**HOLLYWOOD BOWL RENOVATION PROJECTS:
APPROVE ADDENDUM 1 TO THE
MITIGATED NEGATIVE DECLARATION FOR THE
RENOVATIONS TO HOLLYWOOD BOWL FOOD AND
BEVERAGE FACILITIES PROJECT; AND
APPROVE REVISED PROJECT BUDGET FOR THE
HOLLYWOOD BOWL SHELL REHABILITATION AND
ACOUSTICAL IMPROVEMENTS AND THE BACK-OF-HOUSE
ENHANCEMENT PROJECT ELEMENTS
SUPERVISORIAL DISTRICT 3
3 VOTES**

**ADDENDUM NO. 1 TO THE FINAL MITIGATED NEGATIVE
DECLARATION RENOVATIONS TO THE HOLLYWOOD BOWL
FOOD AND BEVERAGE FACILITIES**

State Clearinghouse Number 2001101166

February 3, 2004

FIGURE 2.1-2
Schematic Drawing of Refined Concession Stand No. 4

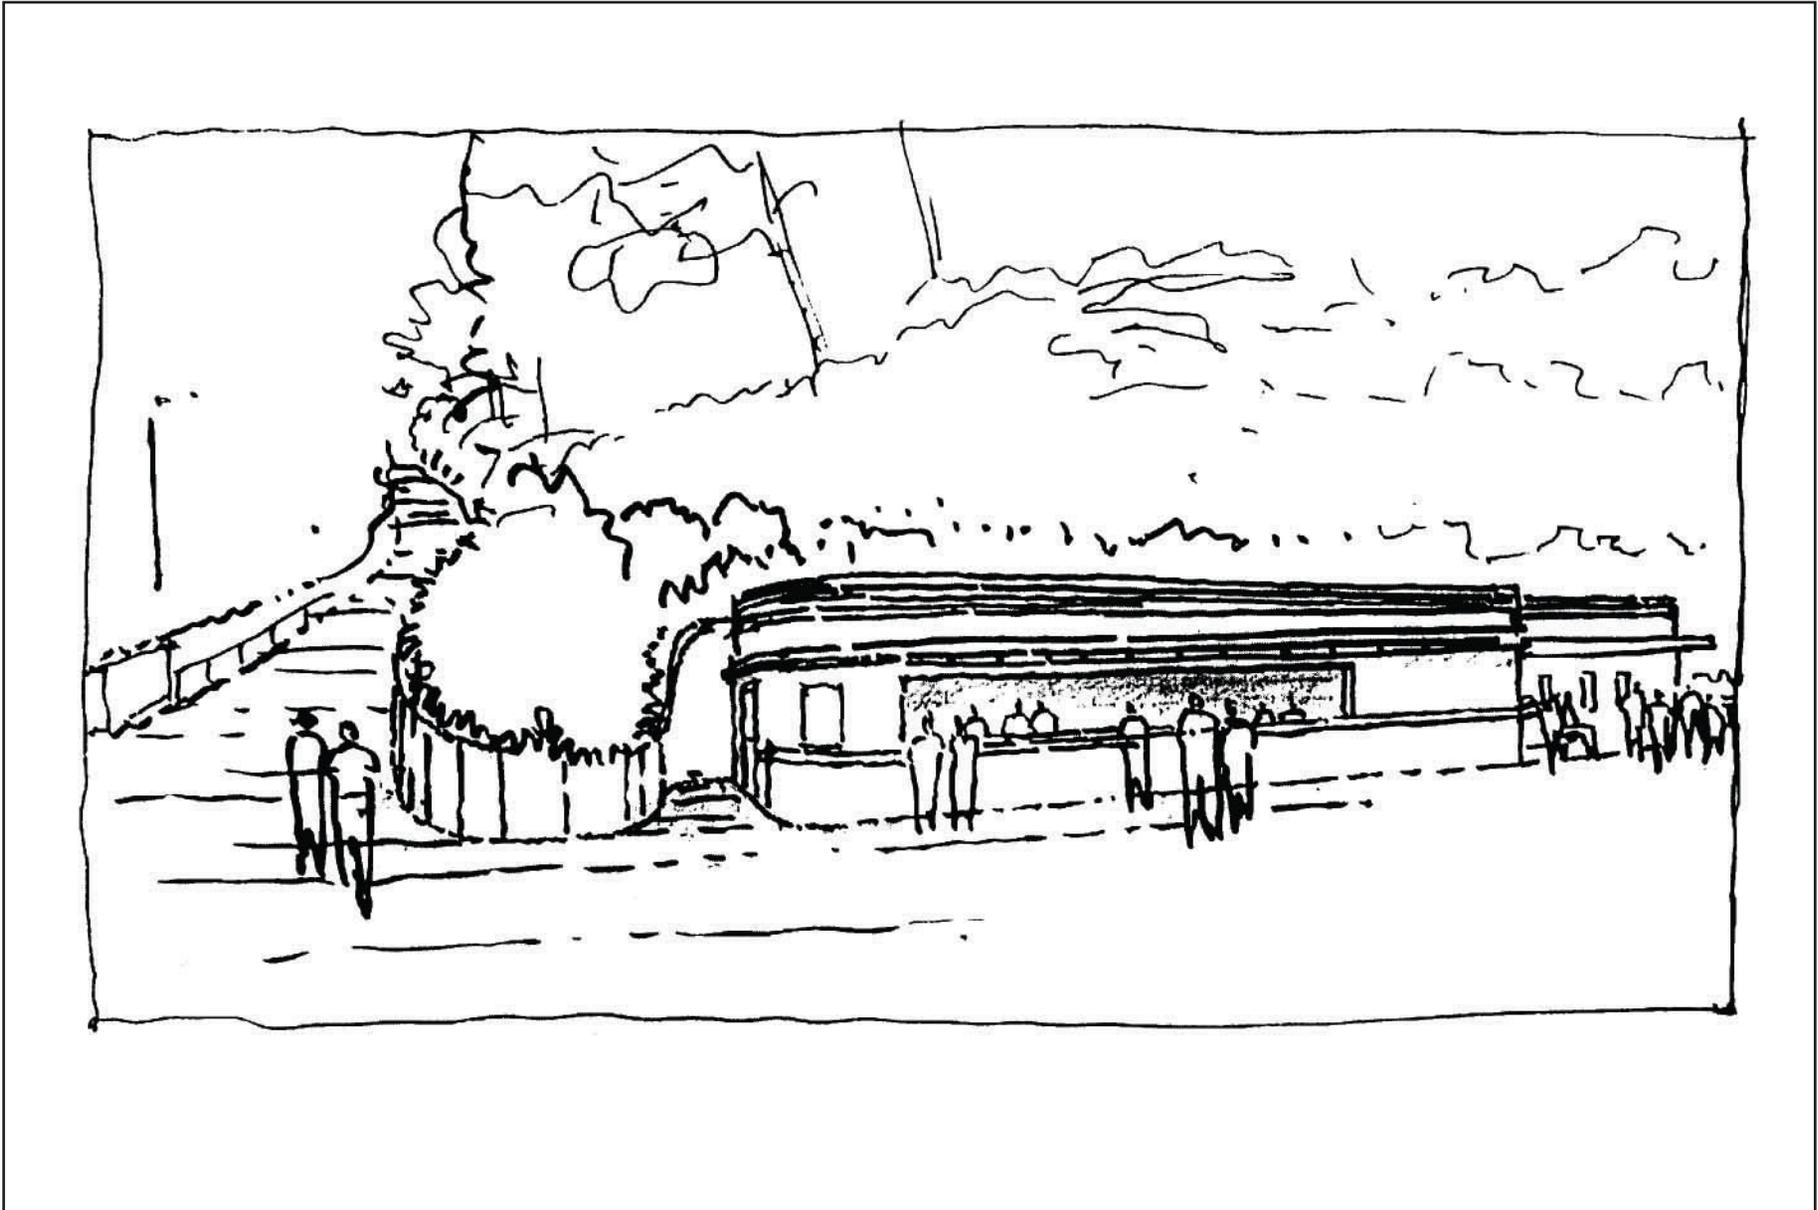
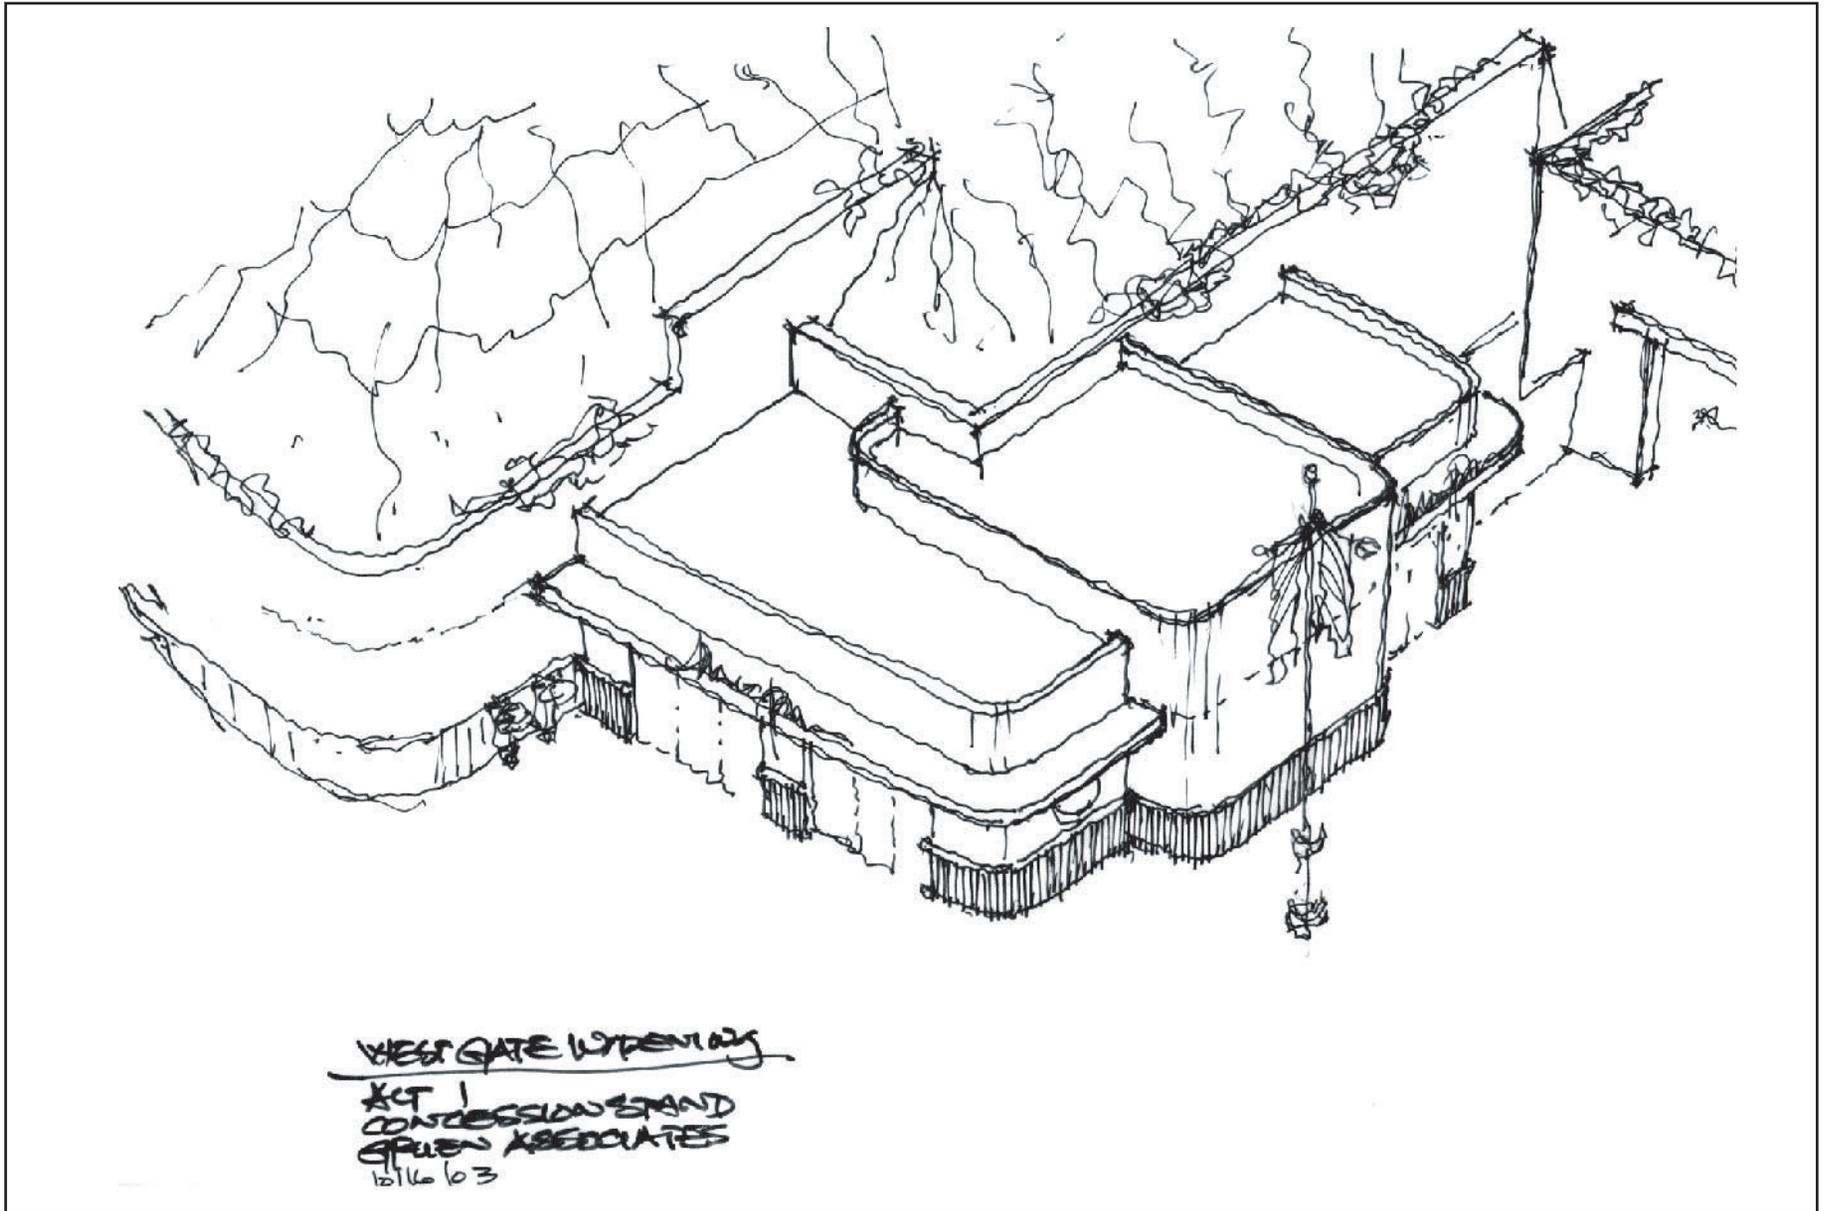
The MND proposed replacing the existing 230-square-foot Concession Stand No. 4 with a new 440-square-foot Concession Stand No. 4 to be located approximately 20 feet to the east and oriented perpendicular to the existing concession stand across the west gate concourse between the parking lots to the Hollywood Bowl stands (Figure 2.1-1, *Illustration of Adopted Concession Stand No. 4*).

The proposed refinement to this project element would increase the size of the new Concession Stand No. 4 from 440 square feet to a maximum of approximately 1,000 square feet (Figure 2.1-2, *Schematic Drawing of Refined Concession Stand No. 4*, and Figure 2.1-3, *Site Plan of Refined Concession Stand No. 4*). The approximately 1,000-square-foot concession stand would be relocated in the same area as described in the MND. However, the design of the concession stand would change from a long and narrow building with an approximately 20-foot-high retaining wall located between the building and the slope to an L-shaped building with at most a 23-foot-high retaining wall located between the building and the slope.

The increase in size reflects a change in the type of concession stand proposed in this location. The existing and adopted Concession Stand No. 4, as described in the MND, is a walk-up concession stand with three exterior service windows. This type of concession stand limits service to a one-to-one staff-to-patron ratio and can result in long exterior queues that may interfere with adjacent circulation patterns. The refined Concession Stand No. 4 would consist of an indoor concession area that routes patrons through the stand to select from a cafeteria-type display to several checkouts stationed at the exit. In the event of a service queue, where there are more concession patrons than can be accommodated inside the stand, patrons would be directed to line up against the south side of the building and out of high circulation areas by means of a temporary and removable guardrail and signage. This type of concession stand was implemented through Concession Stand No. 3, located on the east side of the Hollywood Bowl stage, as part of Phase I of the MND. This type of concession stand has proven to be both more efficient for the staff and a more positive concession experience by allowing patrons to be served more quickly and to select concessions personally and at their own pace. Therefore, this type of concession stand more effectively meets the primary project element objective of improving the efficiency of service to patrons and reducing congestion in the vicinity of the west gate.

FIGURE 2.1-4
 Option A Retaining Wall Plan

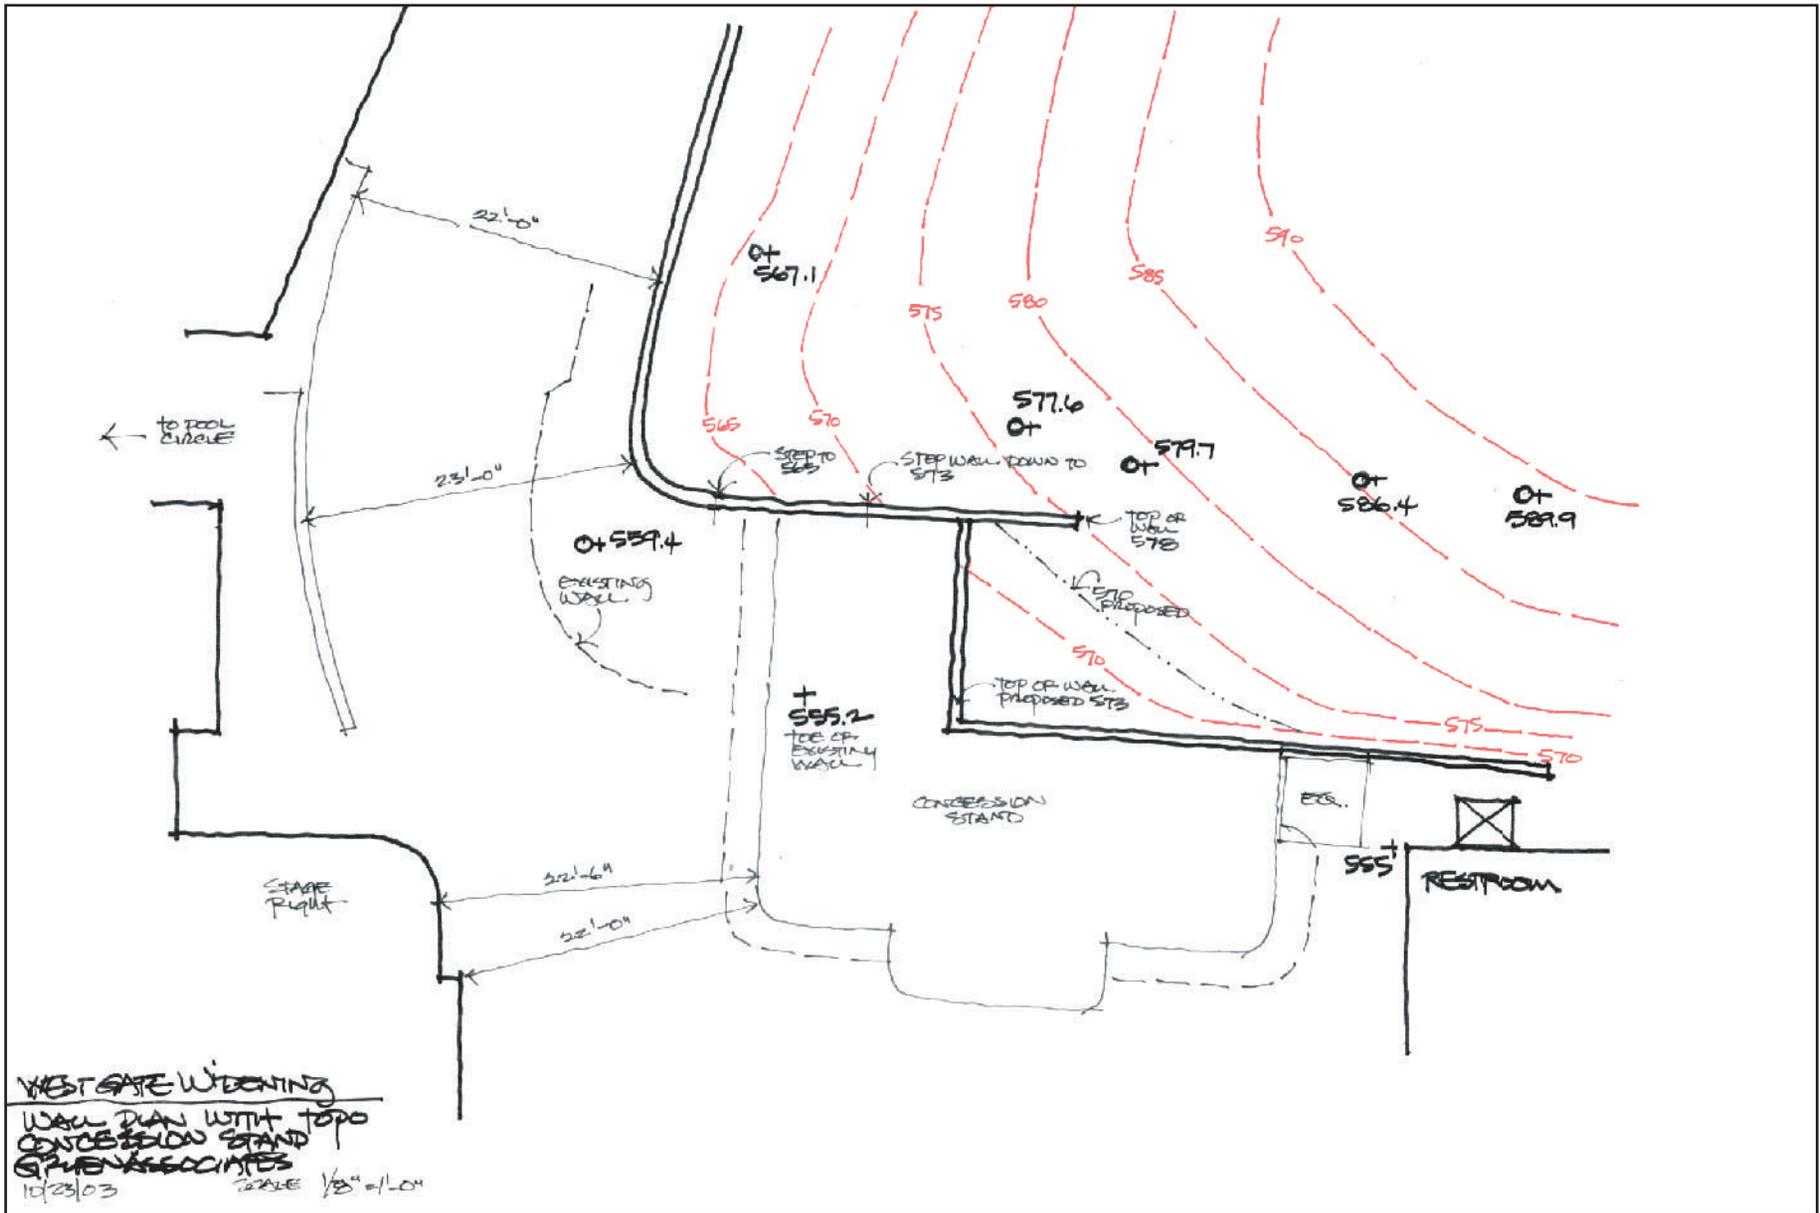
The retaining wall in Option A is about 70 to 75 linear feet in length and ranges in height from about 7 to 23 feet (Figure 2.1-4, *Option A Retaining Wall Plan*). To accommodate the L-shape of the concession stand, three retaining wall sections are required: the first, about 16 feet high extending east from the restroom; the second, joining the first and extending south into the slope face; and the third, extending east again then south to merge with the existing retaining wall along the pedestrian walkway. Preliminary estimates suggest that Option A would require slightly less excavation volume than the adopted design, but both volumes are small and neither is significant compared to the overall project.

The retaining wall in Option A is about 70 linear feet to 75 linear feet in length and ranges in height from about 7 to 23 feet. Preliminary estimates indicate that the project refinements would not require additional excavation volume than the adopted Concession Stand No. 4. A geotechnical expert from Wilson Geosciences reviewed the MND, the geotechnical reports prepared for the project site, and the proposed project refinements and found, based on the available information, that the proposed refinements would not result in new or more significant impacts related to geology and soils than the adopted design with the implementation of the mitigation measures identified in the MND² (Attachment 1, November 14, 2003, Letter from Wilson Geosciences).

FIGURE 2.1-5
Option B Retaining Wall Plan

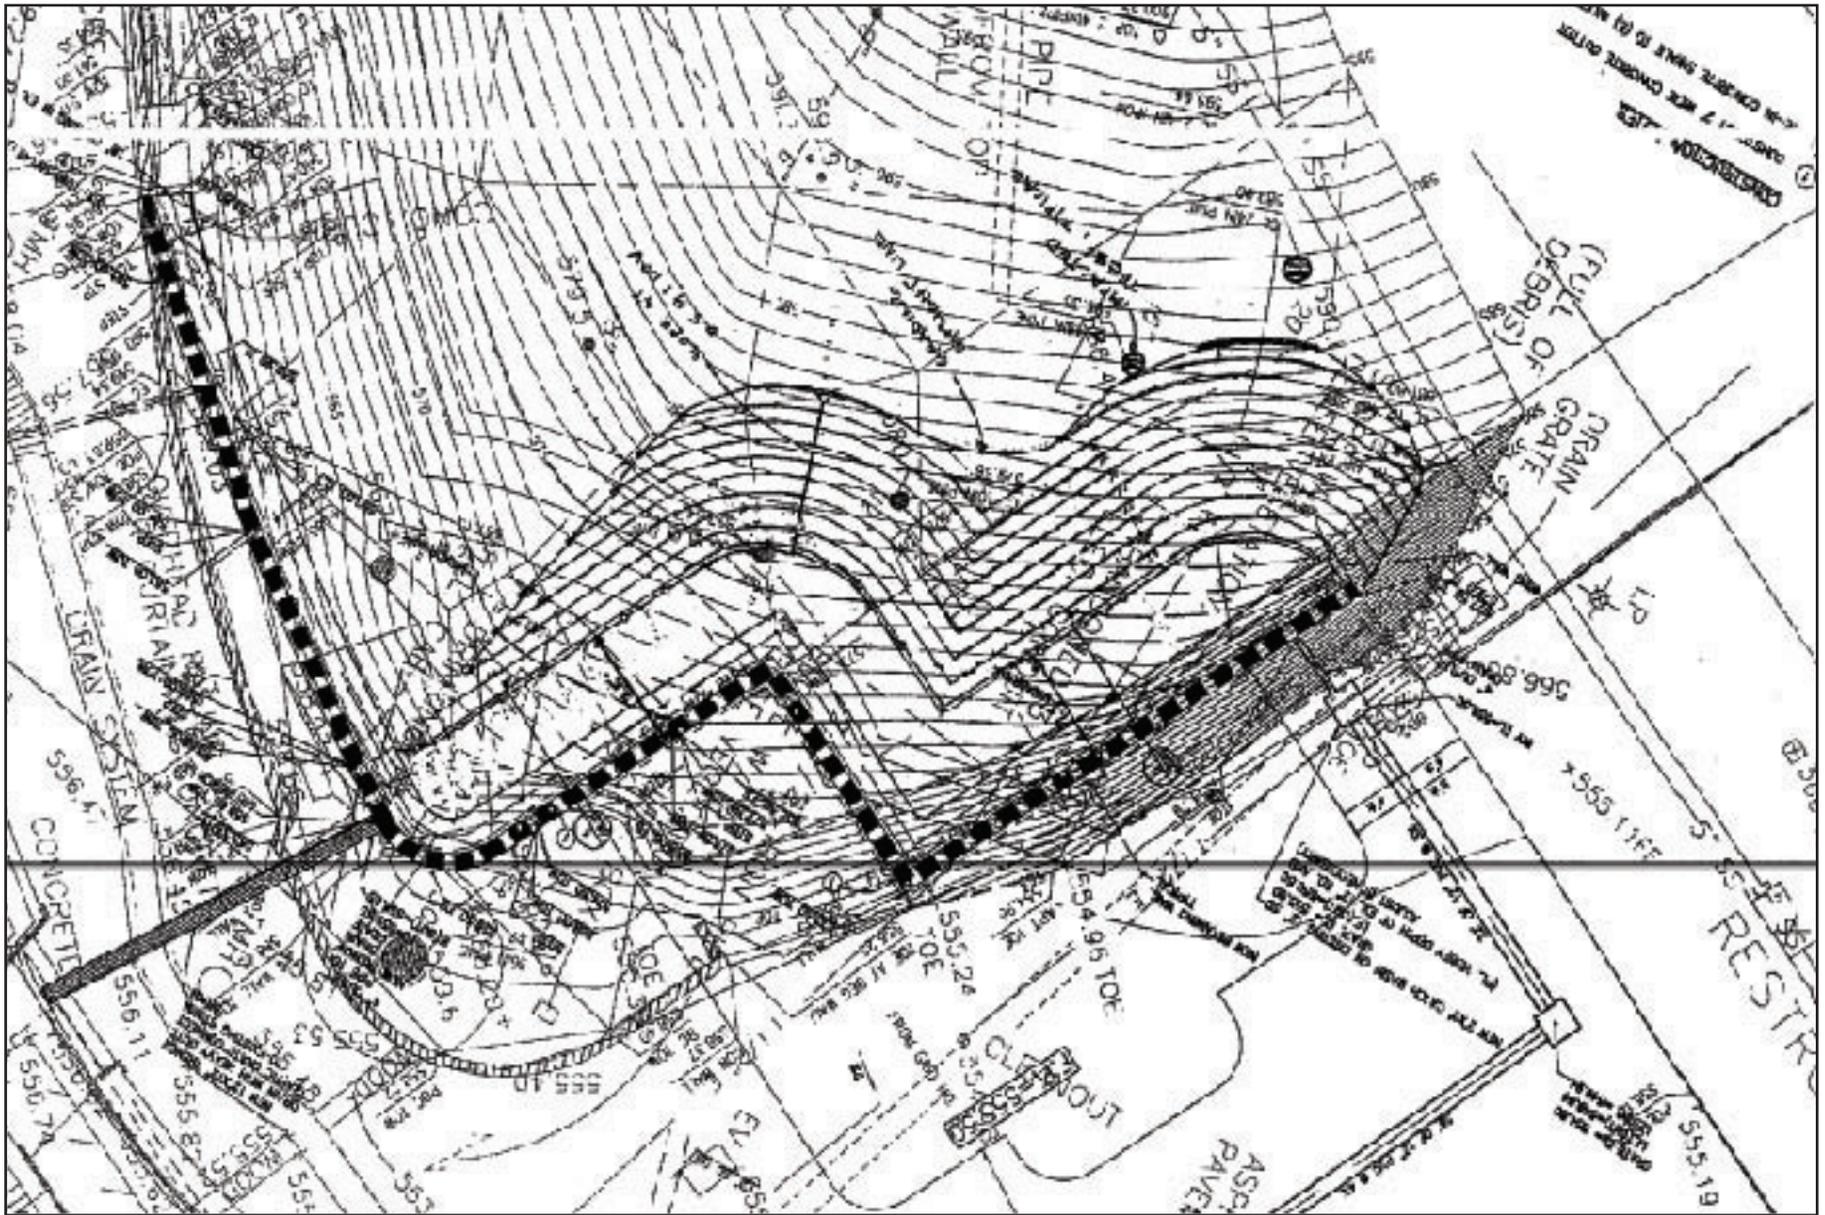
The retaining wall in Option B is also about 70 to 75 linear feet in length and would consist of retaining wall sections similar to those described in Option A above (Figure 2.1-5, *Option B Retaining Wall Plan*). The retaining wall in Option B is anticipated to be shorter than that described in Option A. Nonetheless, this analysis considers the maximum height to be 23 feet, thus providing a reasonable worst-case scenario. A shorter retaining wall requires additional excavation. Preliminary estimates suggest that Option B would require approximately 400 cubic yards of excavation, which is not significant compared to the overall project. However, 200 cubic yards would need to be transported off site, requiring approximately 20 truck trips.

The retaining wall in Option B is also about 70 to 75 linear feet in length and has a maximum height of 23 feet. Preliminary estimates suggest that Option B would require approximately 400 cubic yards of
